**RE: Objection to the Hunter Indoor Sports Centre Development (SSD-65596459) – 2 Monash Road & 24 Wallarah Road, New Lambton**

**Attachment A – Detailed Assessment**

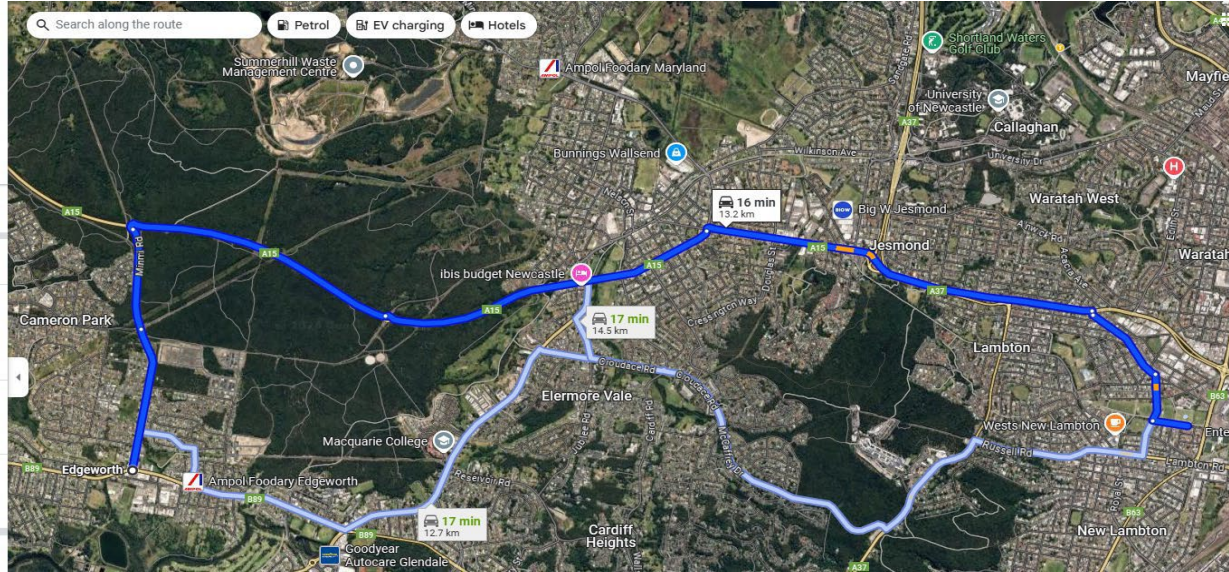
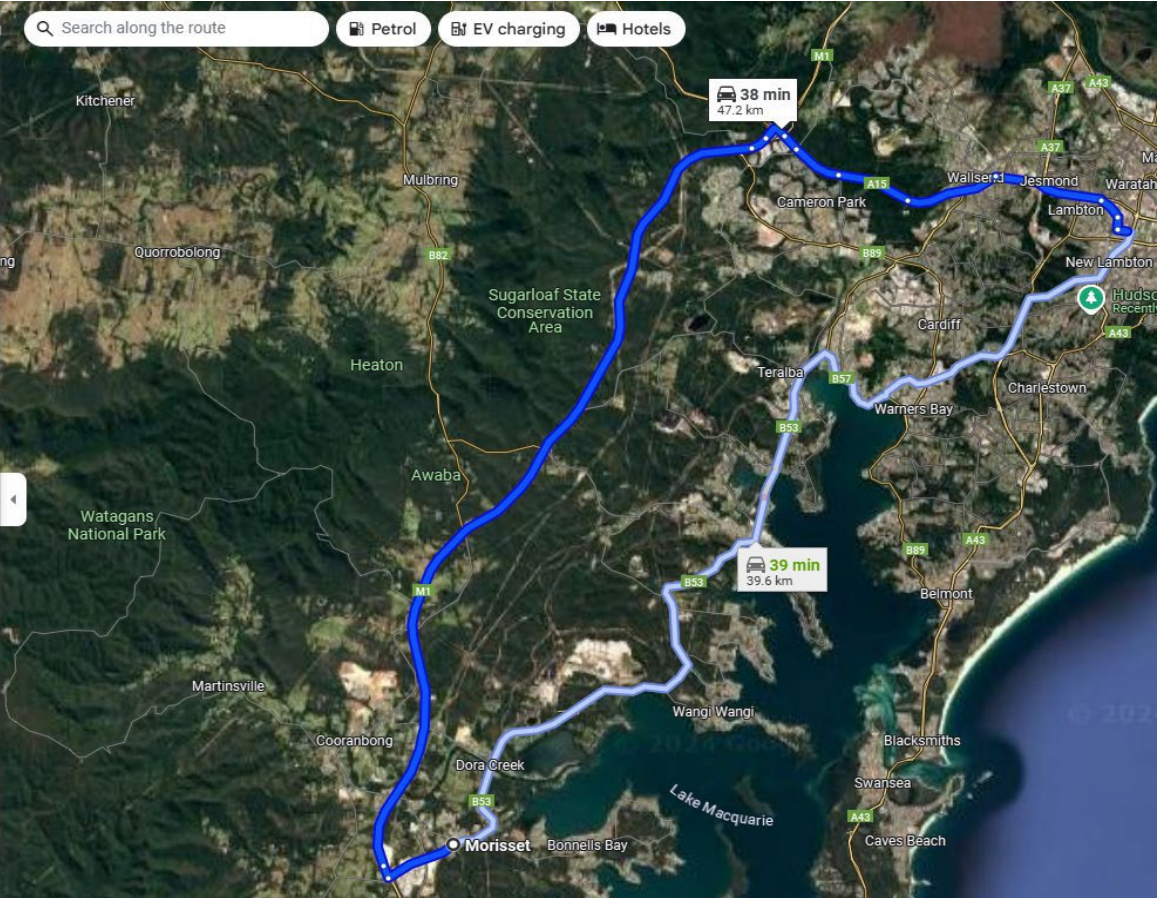
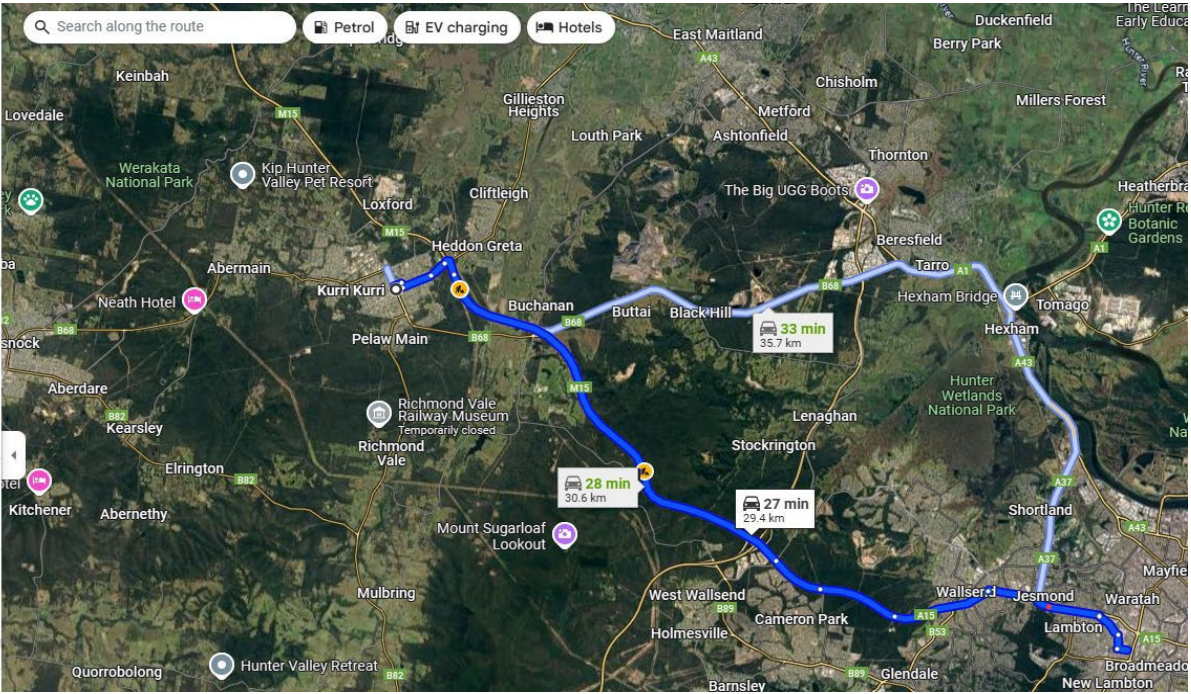
*From Wallsend to proposed development – Google maps shows preferred route via Young Road, Wallarah Road and alternate route via Howe Street and Hobart Road*

From Edgeworth to proposed development – Google maps shows preferred route via Young Road, Wallarah Road and alternate route via Russell Road and Wallarah Road

From Maryland to proposed development – Google maps shows preferred route via Young Road, Wallarah Road

From Morisset to proposed development – Google maps shows preferred route via Young Road, Wallarah Road

From Kurri Kurri to proposed development – Google maps shows preferred route via Young Road, Wallarah Road

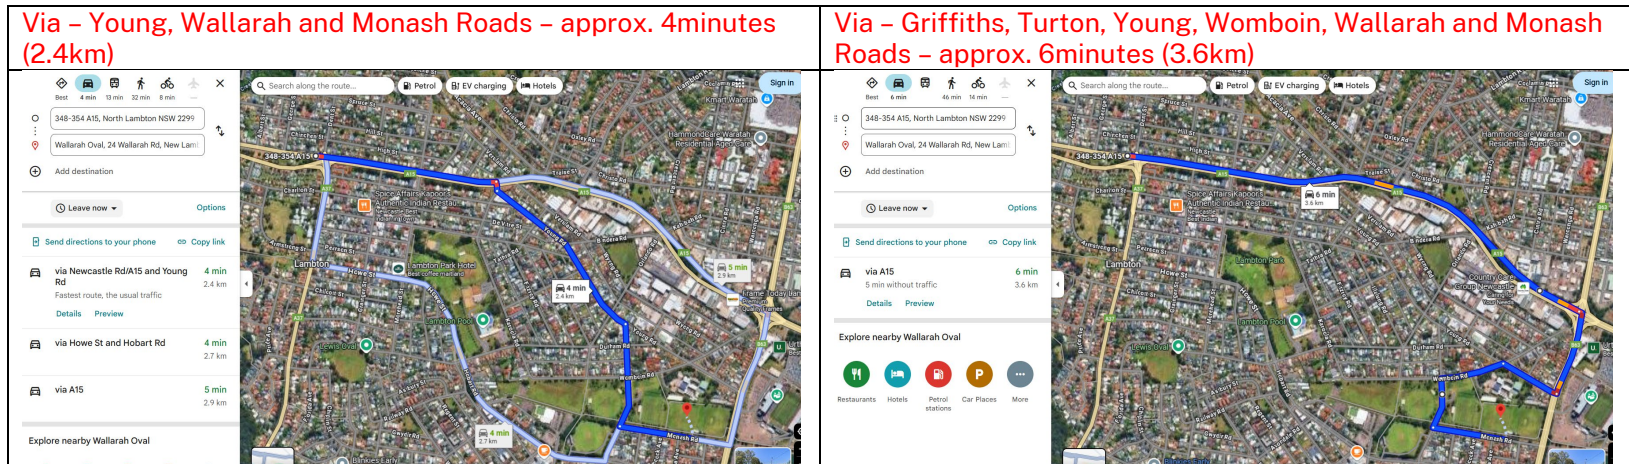
To clearly indicate the point of traffic distribution the example below shows difference in travel time and distance from the intersection of Griffiths Road and Croudace Road to the proposed development is shown below. The additional time and km travelled in the below example is approx. 2 minutes and an additional 3 sets of traffic light signal intersections and 1.2km. This is clearly not the route that traffic will take to access the development.

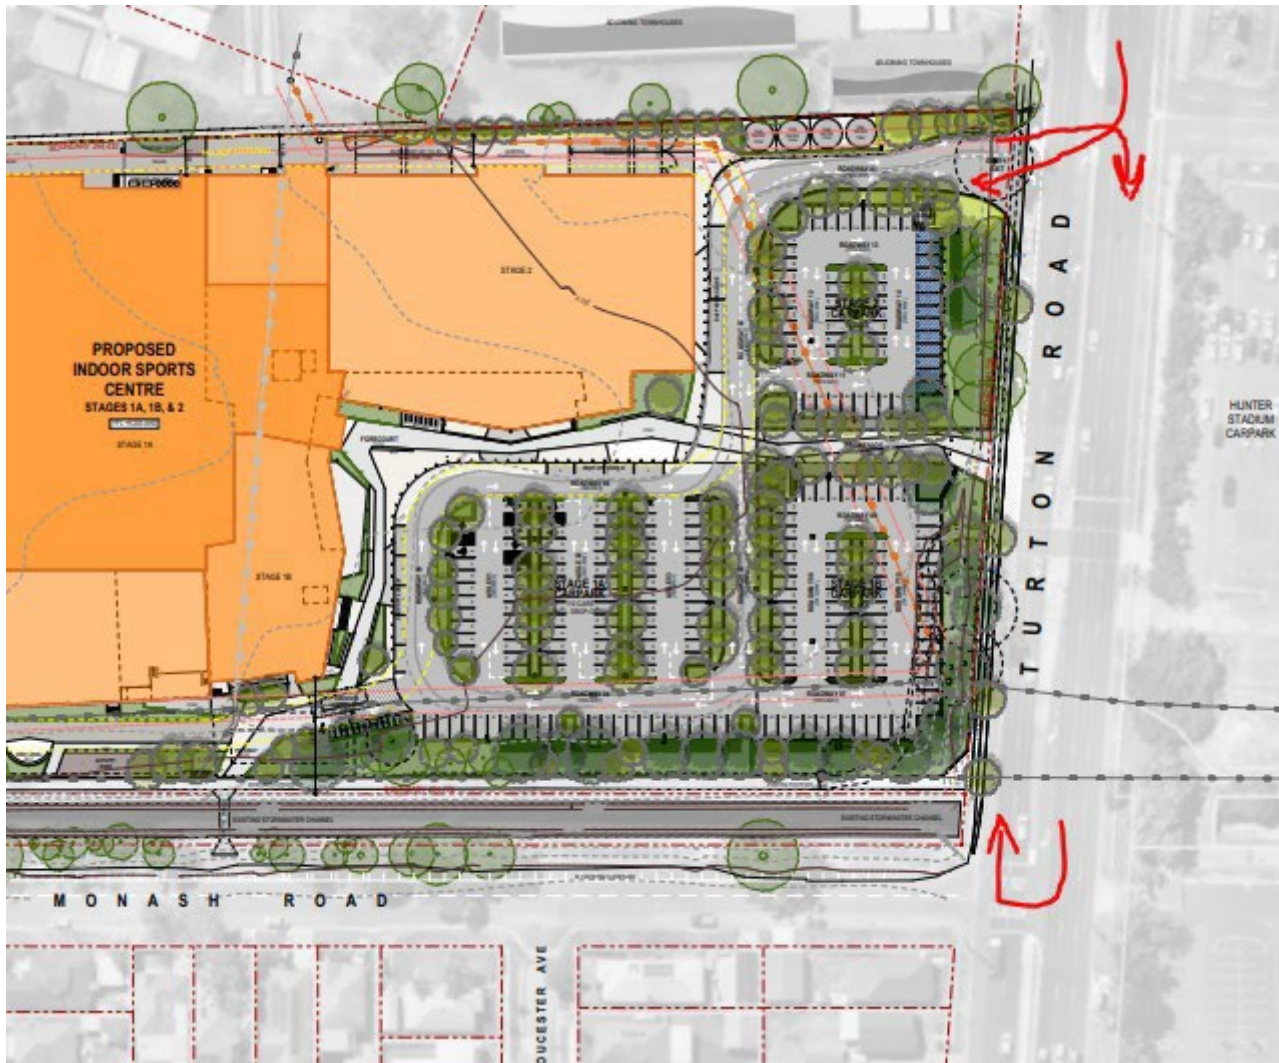
3. The footpath along Turton Rd is narrow and the development will generate increased pedestrian movements in the area that do not appear to have been accommodated. This may lead to pedestrians being forced onto the adjacent verge area and may pose a risk to pedestrians (particularly young children and the elderly) who may lose balance on unstable ground with potential for slips, trips and falls, nearby the large concrete drain (Lambton Ker-rai Creek) – the footpath has been widened at the front of the development on Turton Road, but there is still a risk associated with pedestrian and cyclist safety, with potential conflicts between cyclists using the R5 Broadmeadow to Brickworks cycle route adjacent to Lambton Kerraik Creek and pedestrians who propose to use the new HISC facility (particularly young children and the elderly) who may lose balance on unstable ground with potential for slips, trips and falls, nearby the large concrete drain.

#### 5.5.5 Proposed Parking Supply

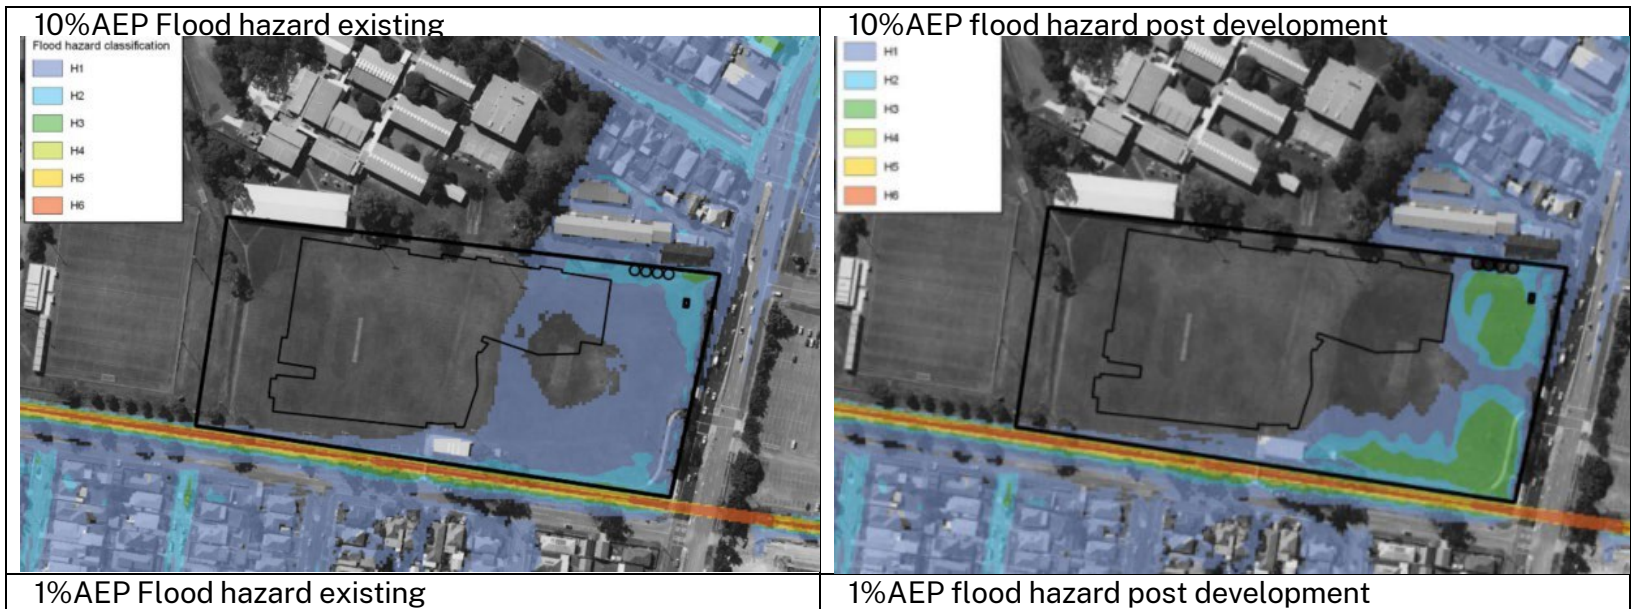
This hardly seems like enough parking for the full Stage 1 and Stage 2. Where will the overflow parking be located? What about other competing sports such as those at McDonald Jones Stadium (MJS), Arthur Edden Oval, Hockey Centre and Wests Cricket and Rugby League.

Section 5.5.5 of TIA indicates that overflow parking would be at MJS, however Venues NSW indicated that this wouldn't be available for use.

Figure: **A-3** Information shown on this figure is compiled from numerous sources and may not be complete or accurate. Torrent Consulting cannot be held responsible for the misuse or misinterpretation of any information and does not accept any liability for any loss, damage or compensation.

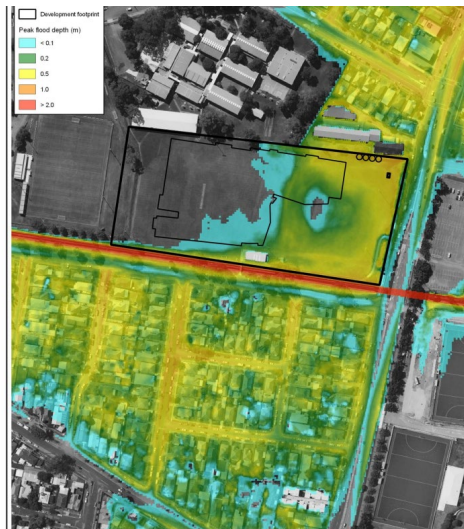
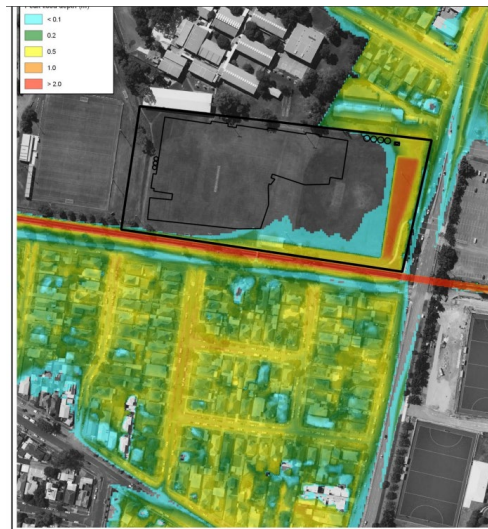
C3 map should be the difference between A3 and B3, but clearly it is not showing that, why not?

In the existing 1% event the extent of flood depth is much more across the site with green being 0.2m flood depth and yellow up to 0.5m flood depth.

In the post development 1% event the extent of flooding is generally around the edge of the carpark and within the swale drain, this appears somewhat justified and expected based on the swale drain being cut adjacent Turton Road and the fill placed onto the site to raise the carpark

However, the afflux map C-3 doesn't show the increased afflux in the swale drain, or the reduction on Blackley Oval and part of Wallarah. Therefore, I question that it is correctly showing the afflux within other parts of the model adjacent to the project, particularly the houses to the south of the development.
